**LAKE PONTCHARTRAIN, LA.
AND VICINITY
LAKE PONTCHARTRAIN
HIGH LEVEL PLAN**

**DESIGN MEMORANDUM NO. 19
GENERAL DESIGN**

**ORLEANS AVENUE
OUTFALL CANAL**

ENGINEERING CORRESPONDENCE LOG

FIGURE 2

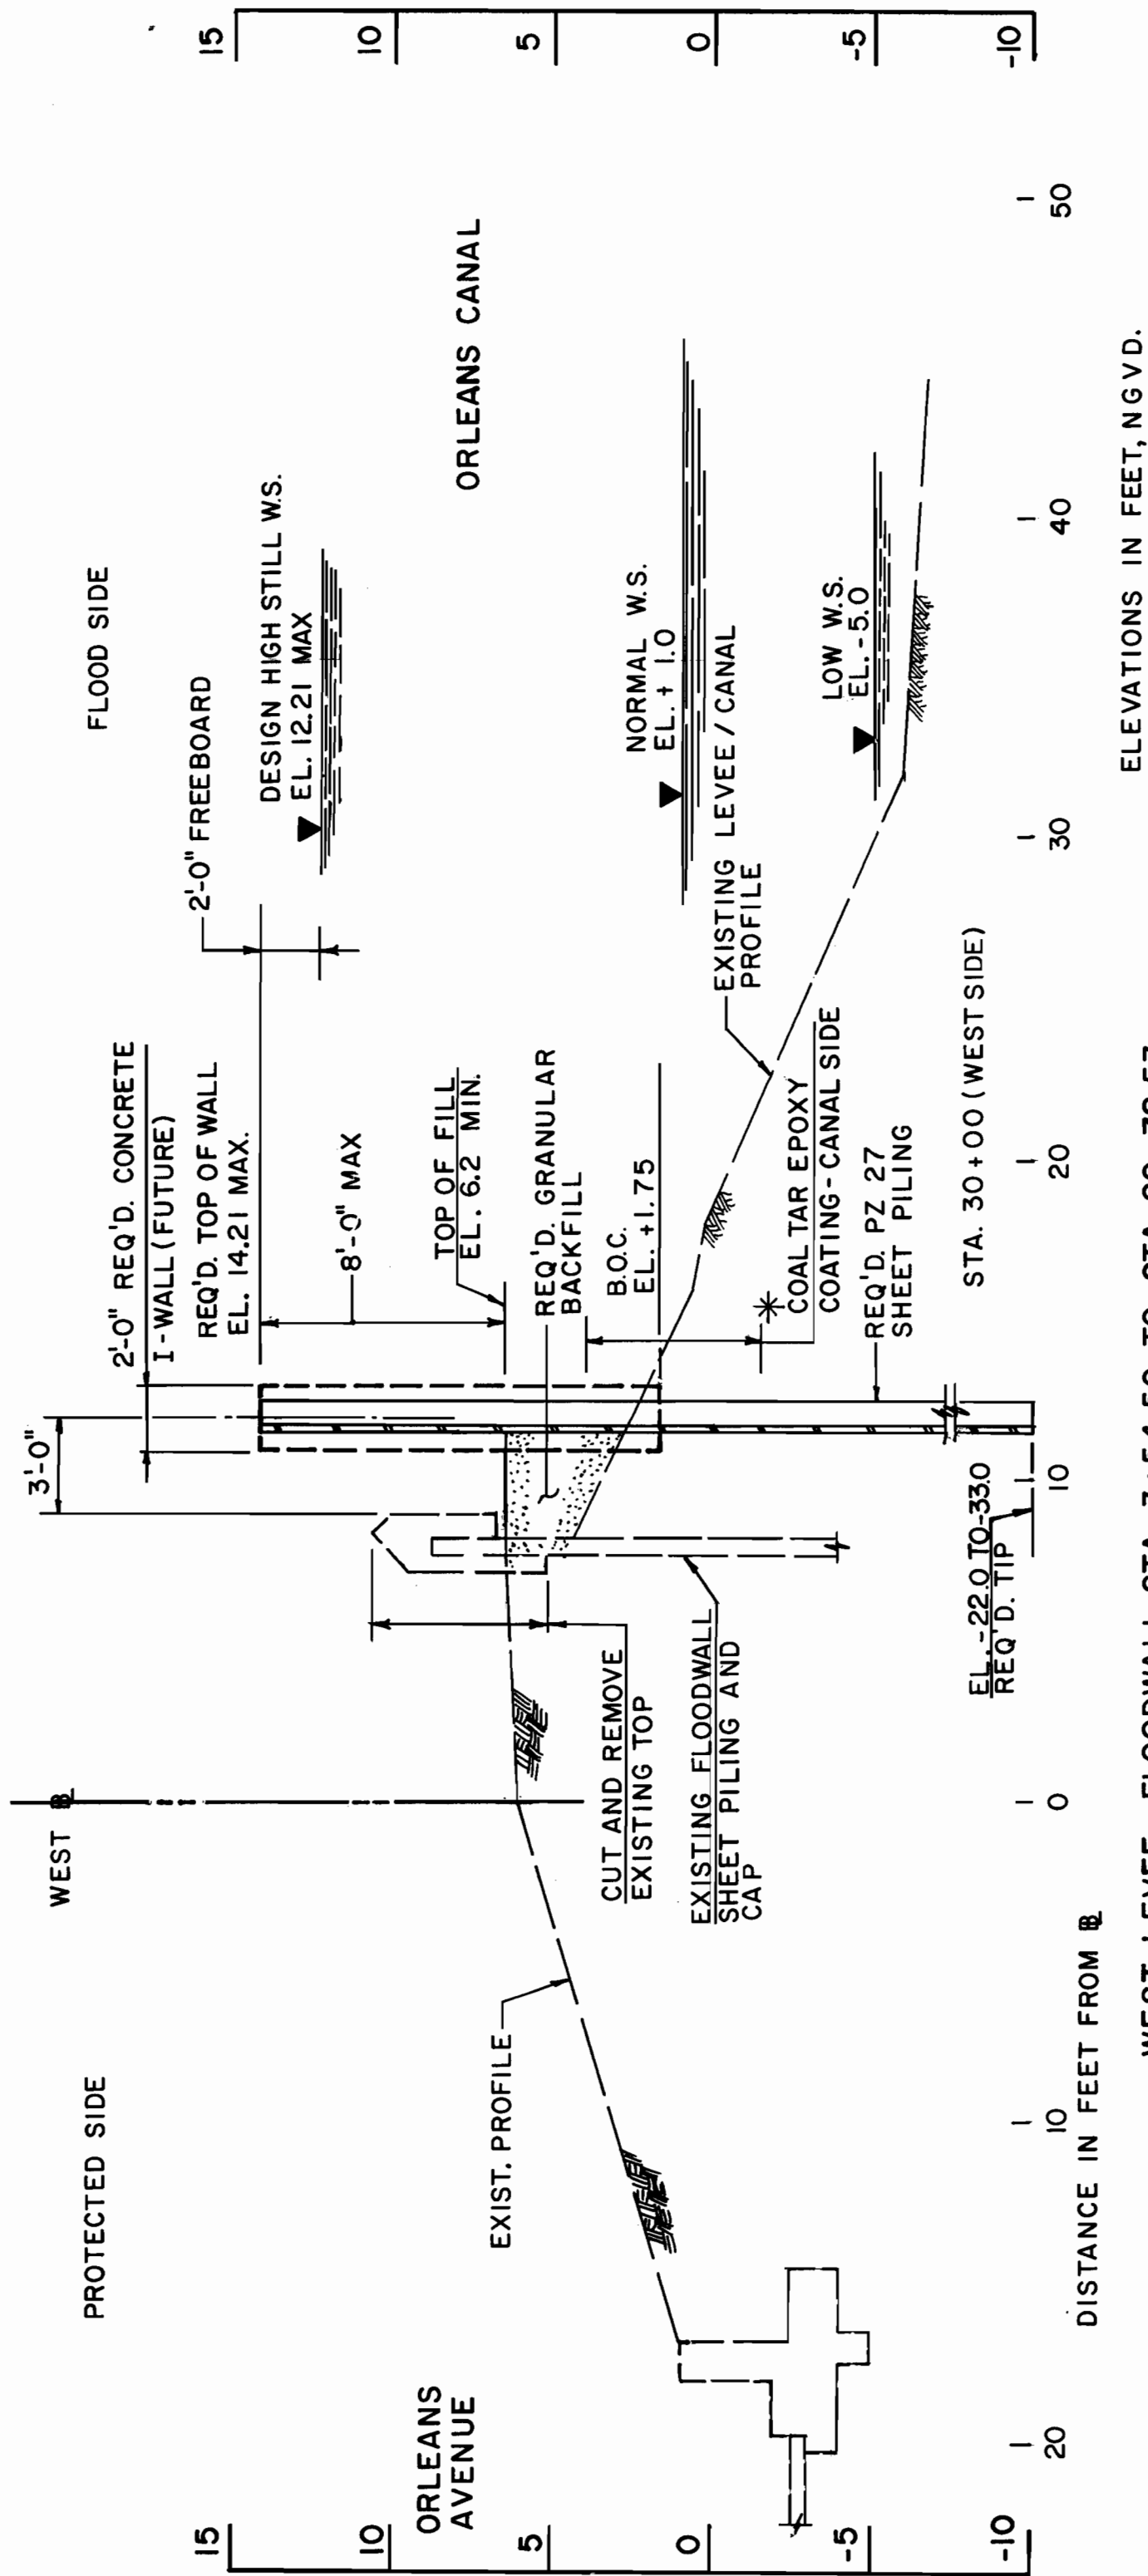
16. Page V-4, paragraph 4, figure 2, and figure 7 - The draft geotechnical report has a tip elevation of -37.5 NGVD for the I-wall between sta. 50+00 and sta. 90+00, whereas figures 2 and 7 show a tip elevation of -33 NGVD. Reference comment 15 in our February 10, 1986 letter.

19. Figure 2 - The proposed elevation limits for coating the steel sheet piling with coal tar epoxy should be provided. It should be noted that the use of the coal tar epoxy, in lieu of the requirements of para. IV.D.1, is only permitted in this reach.

Comment 19. The elevation limits for coating the steel sheet piling will be shown in Figure 2.

FIGURE 4

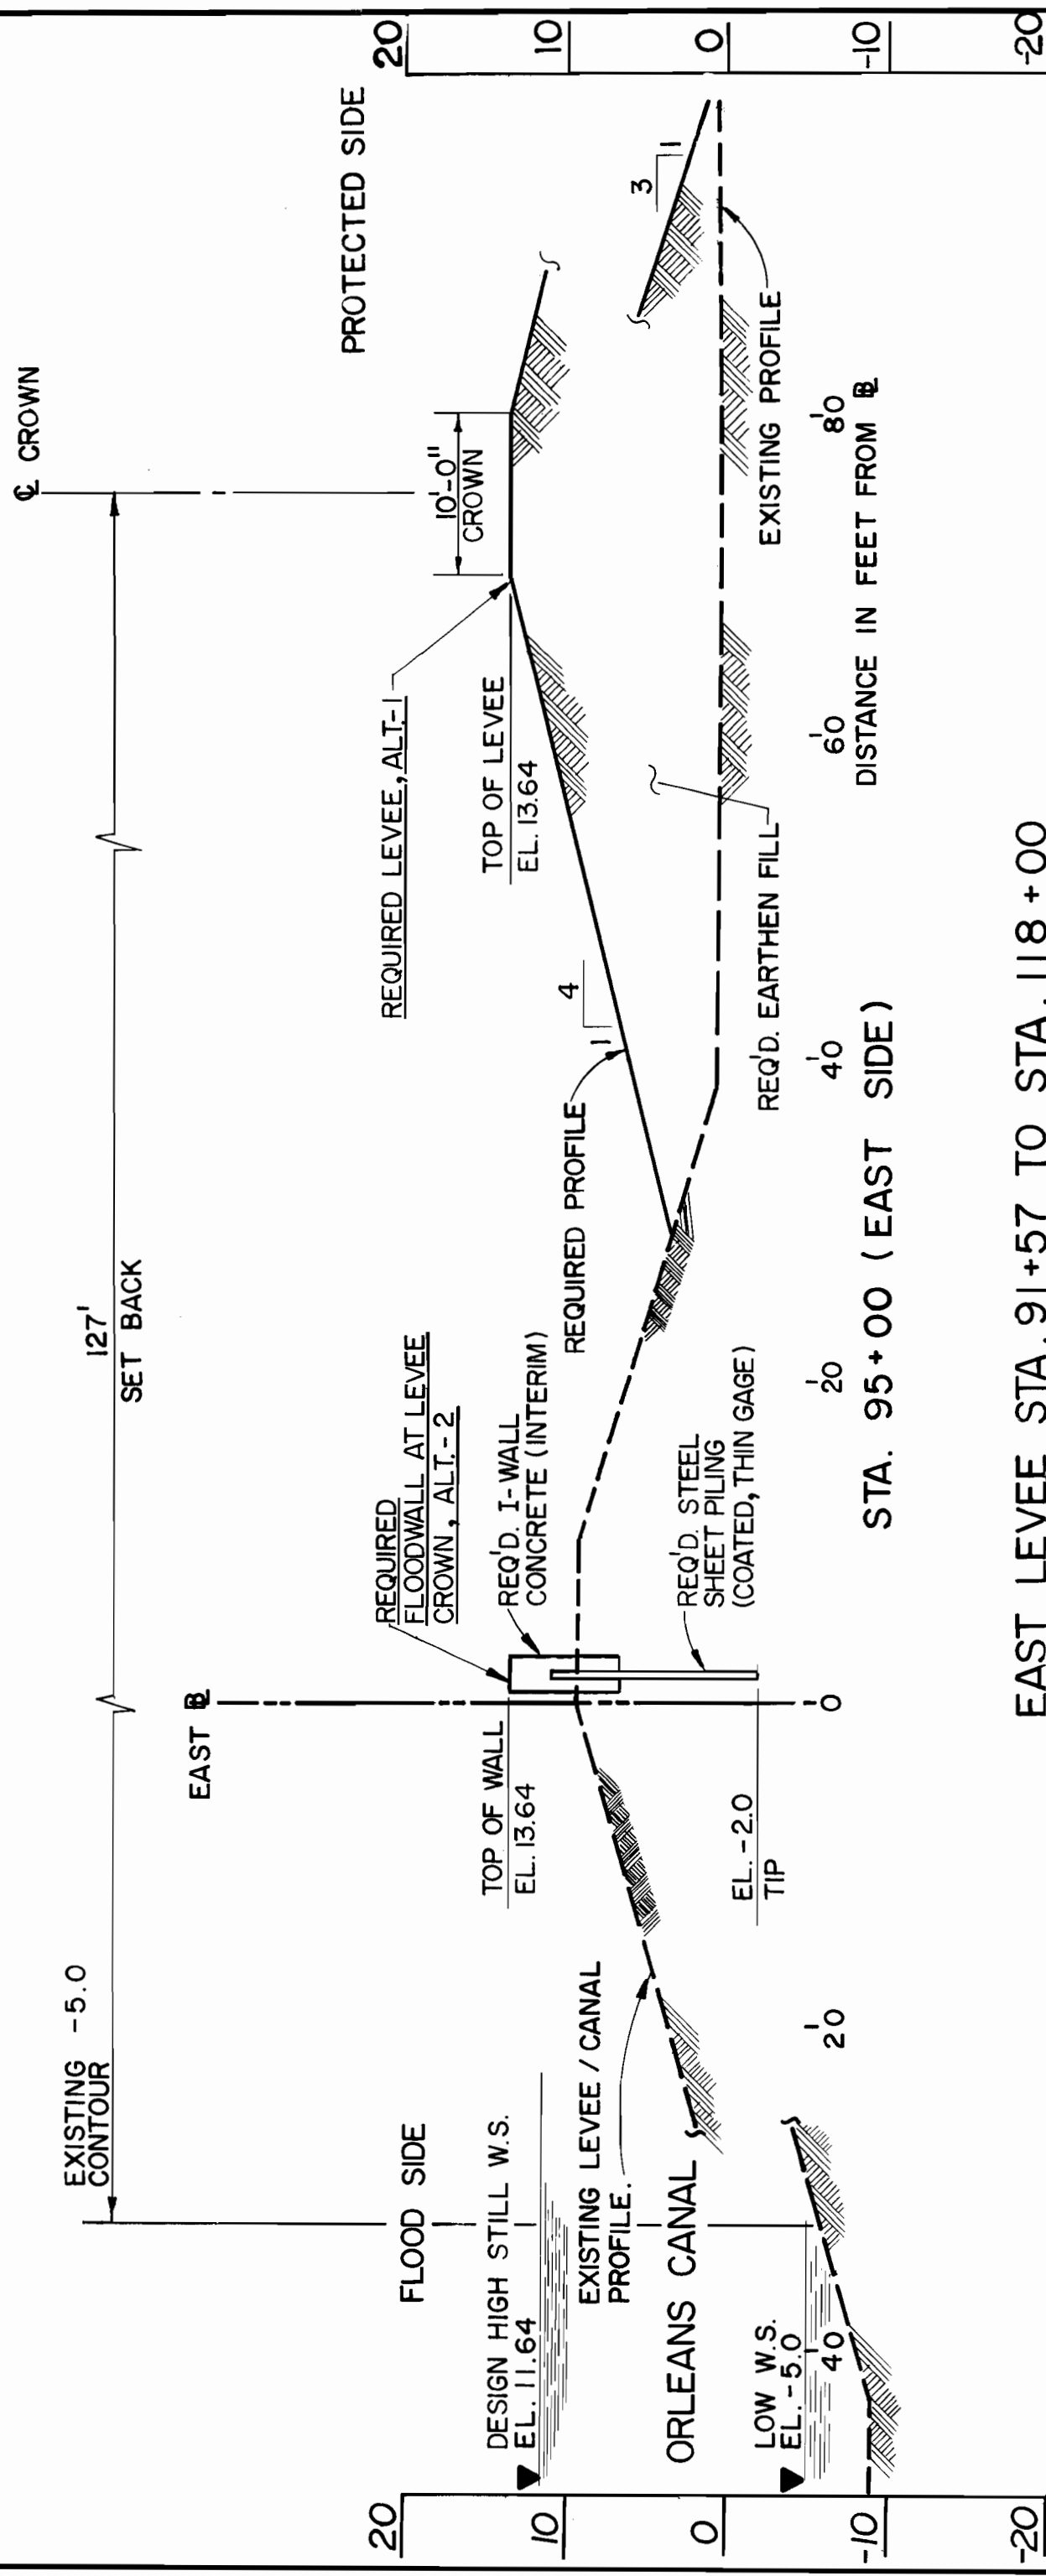
20. Figure 5 - It appears that this proposed section is for the west side, and not the east side as shown. This should be resolved.

FIGURE 7

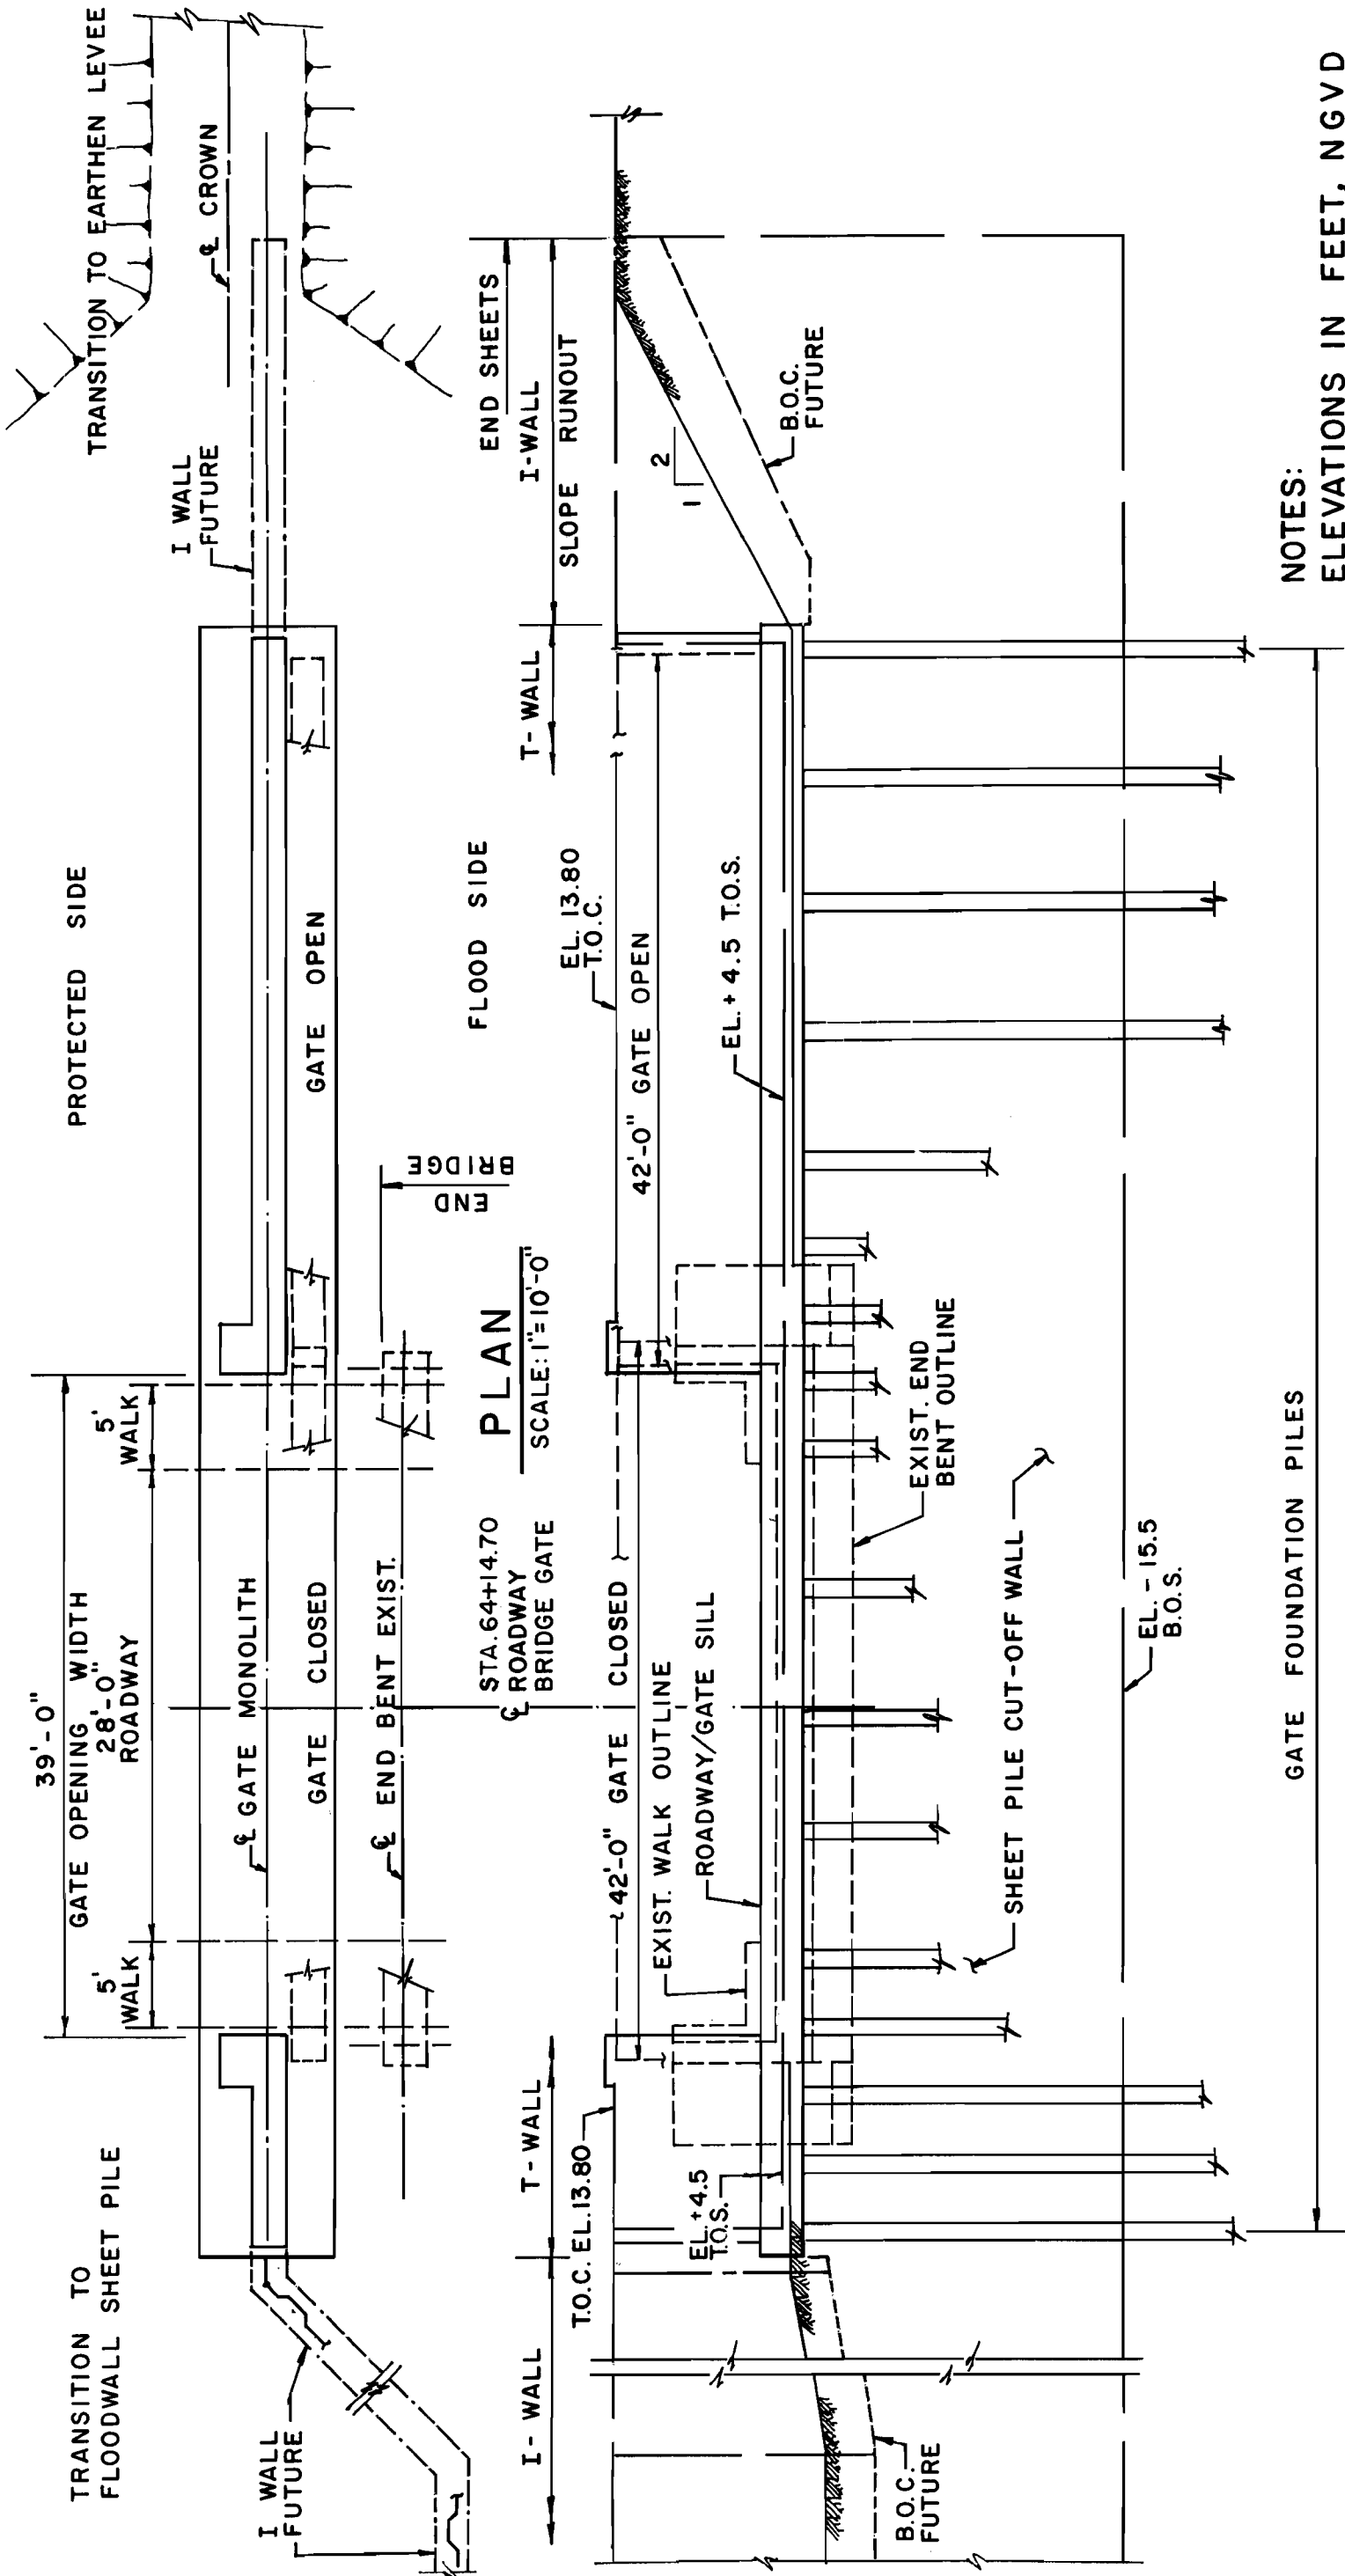
25. Reference figure 7, a. - It is suggested that another alternative be investigated for storing the roller gate. In some cases, we have found that an I-wall in combination with an adjacent pile-founded concrete slab is more economical than a pile-founded T-wall. The additional

26. Reference figure 7, b. - A stabilization slab should be added beneath the T-wall monolith(s). The NOD normally provides a 4-inch thick stabilization slab.
